**Framatome ANP Document No. 51-5015197-01,  
"Surry 1 & 2 Reconciliation with Turkey Point 3 RV Hd & CRM Noz."**

Title SURRY 1 &amp; 2 RECONCILIATION WITH TURKEY POINT 3 RV HD &amp; CRM NOZ.

This report documents the applicability of engineering analyses performed for the Turkey Point 3 (TP-3) Nuclear Power Plant (NPP) with the Surry 1 & 2 NPPs for the reactor vessel (RV) closure head region of the control rod mechanism (CRM) nozzle penetrations; and the CRM nozzle inside diameter temper bead weld repair. The applicability will be accomplished by a comparison study that includes documenting the engineering data from both TP-3 and Surry NPPs, such as: applicable dimensions of features, materials, and plant operational transients to include time, temperature and pressure.

Figure 1

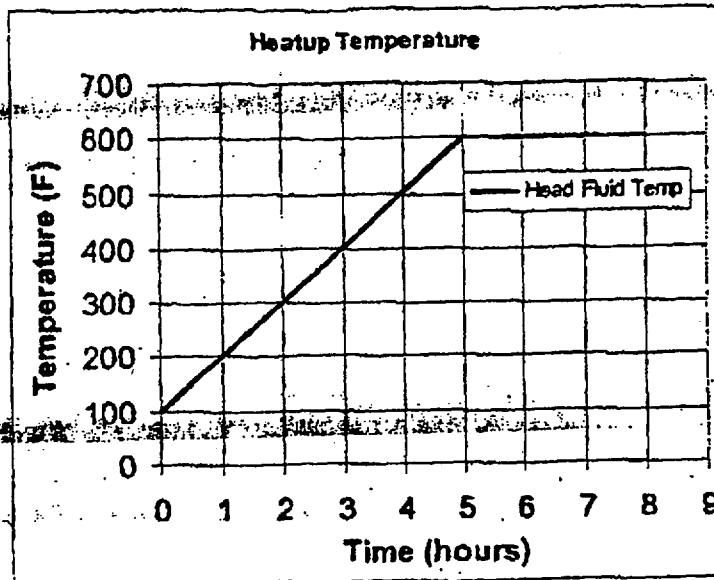
- For heatup, Framatome's heatup curve (Figure 1) shows a rate of 100°F/hr and a range of 100°F to 600°F. This heatup rate matches the design rate for Surry. The range bounds Surry's design range. For design purposes, an ambient temperature of 70°F was assumed, and the no-load RCS temperature is 547°F. Per Reference 4, the full power upper head mean fluid temperature for Surry is 597.8°F. Therefore, the heatup rate and range proposed by Framatome are judged to be bounding. Framatome's heatup pressurization curve (Figure 2) shows an approximate rate of 645 psig/hr. This number does not bound the design value of 740 psig/hr; however, it bounds the actual pressurization rates used during plant heatup.

Figure 3

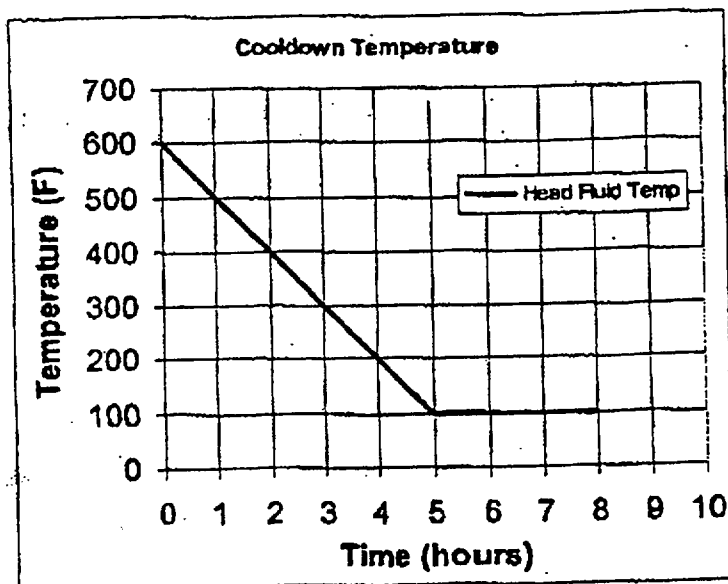
- For cooldown, Framatome's cooldown curve (Figure 3) shows a rate of -100°F/hr and a range of 600°F to 100°F. This cooldown rate matches the design rate for Surry. The range bounds Surry's design range as discussed above. Framatome's cooldown pressurization curve (Figure 4) shows an approximate rate of -645 psig/hr. This number does not bound the design value of 740 psig/hr; however, it bounds the actual rates used during plant cooldown.

Figure 9  
Occurrences  
= 2800

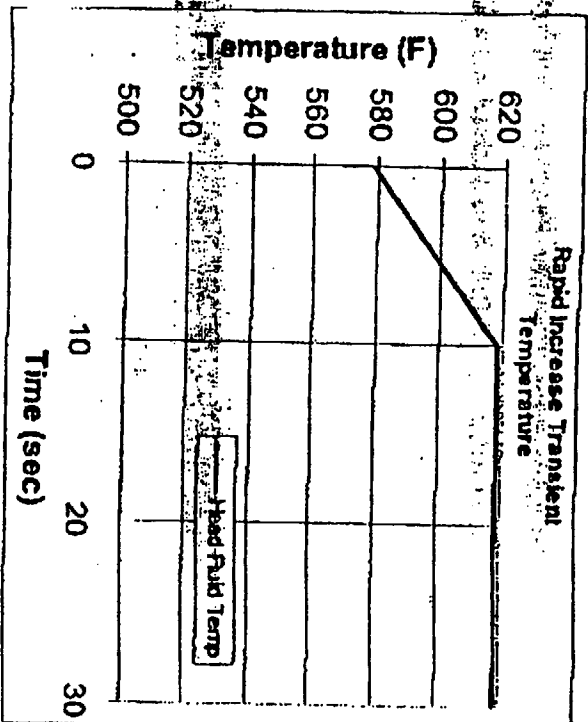
- For the remaining transients of increasing temperatures, Framatome proposes 2800 occurrences of a transient from 577°F to 617°F (+40°F) in 10 seconds (Figure 9), accompanied by a rise in pressure from 2235 to 2585 psig (+350 psi) (Figure 10). For the remaining transients of decreasing temperatures, Framatome proposes 2800 occurrences of a transient from 617°F to 517°F (-100°F) in 10 seconds (Figure 11), accompanied by a drop in pressure from 2235 to 1735 psig (-500 psi) (Figure 12). Review of the 10% step increase, 10% step decrease, large step decrease in load (with steam dumps), loss of load, loss of flow, reactor trip, turbine roll, and loss of power design basis transients show that they are collectively bounded by the transients assumed by Framatome, both in magnitude and number of occurrences.
